Charlotte Department of Transportation

Memorandum

Subject: Rezoning Petition 15-068: Approximately 3.06 acres located on the north side of Dunavant Street between South Tryon Street and Hawkins Street

Figure 1

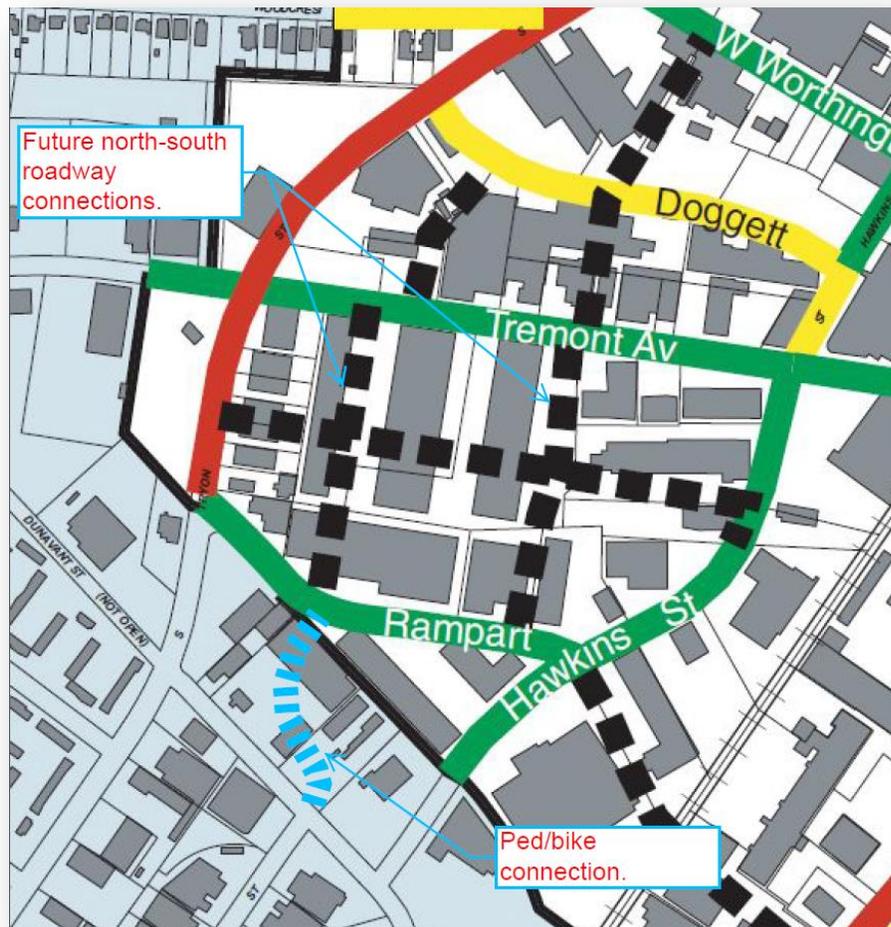
1. CDOT recommends that the petitioner incorporate a pedestrian/bicycle connection through the development which would serve as a linkage between Dunavant Street and Rampart Street. The South End Transit Station Area Plan proposes two future north-south roadway connections from West Tremont Avenue to Rampart Street. This ped/bike linkage would be useful in breaking up the large block length and promoting the overall goal of walking and bicycling in this area. See Figure 1 below. We recognize this commitment is not possible with the proposed conventional zoning district.
